Safety Review

A38 Markeaton Roundabout Improvements and Road Safety Audit

MAL/A38MOA-Rev0

03 March 2020

Image 2: Area of Safety Review Shown in Blue

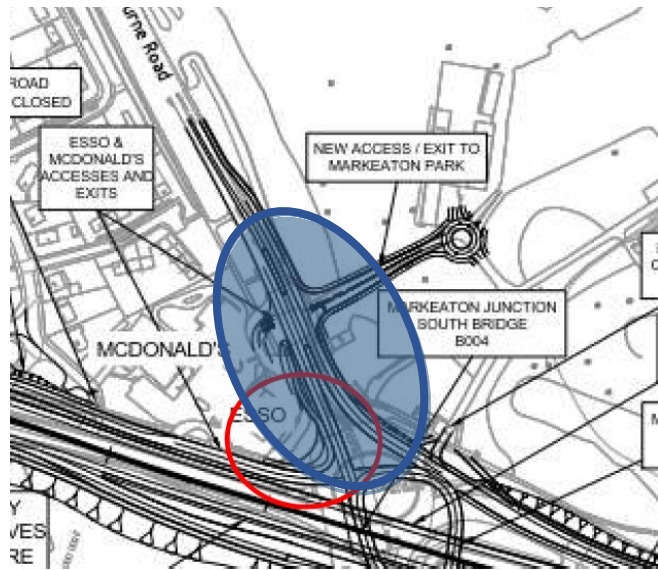
- 2.1.1 Significant changes are proposed at the Markeaton roundabout to improve safety and congestion. The existing entry into the site from the A38 north eastbound direction will be closed. Access to the site will only be available from the A52 Ashbourne Road located to the north of the site.

- 2.1.2 To facilitate these increased turning movements a new signalised junction will be constructed close to the existing Esso/McDonalds access onto the A52 Ashbourne Road. As part of these works the access into Markeaton Park will be incorporated into this junction. Examination of the preliminary layout indicates that the left turn into the site is a radius of 3.5m.

- 2.1.3 The issue of the left turn has been considered within the RSA problem 4.3.5. However, it has not considered the full implications of this extremely tight radii and its effect on the access arrangements for Heavy Commercial Vehicle (HCV) entering the site from A52 Ashbourne Road.

- 2.1.4 An articulated HCV will have considerable difficulty in turning left from the A52 into the site. Details of tracking have been considered but the reality may not be quite so easy to achieve.

- Any driver error will result in over running of the footway increasing the risk of NMU/vehicle collisions.
- Vehicles over running the footway will both damage the footway and may strike traffic signal equipment or other street furniture located close to the entrance.

- It is likely that HCVs will use the offside A52 northbound lane to turn left into the site, drivers travelling northbound would not expect this manoeuvre and as such could increase the risk of side swipe type collisions.

- The radius of the turn is much sharper than drivers would expect and could enter the left turn into the site carrying too much speed resulting in an increased risk of heavy braking resulting in skidding and loss of control type collisions.

- The location of the right turn into McDonalds is very close to the traffic signal junction and could lead to vehicles queuing out onto the A52 resulting in shunt type collisions.

- The right turn does not meet the current standards set out in CD123.

2.1.7 Undertake detailed traffic modelling of the junction and ensure that realistic tracking of left turn HCV's into the site are undertaken. Implement additional signing works for the right turn into the McDonalds.
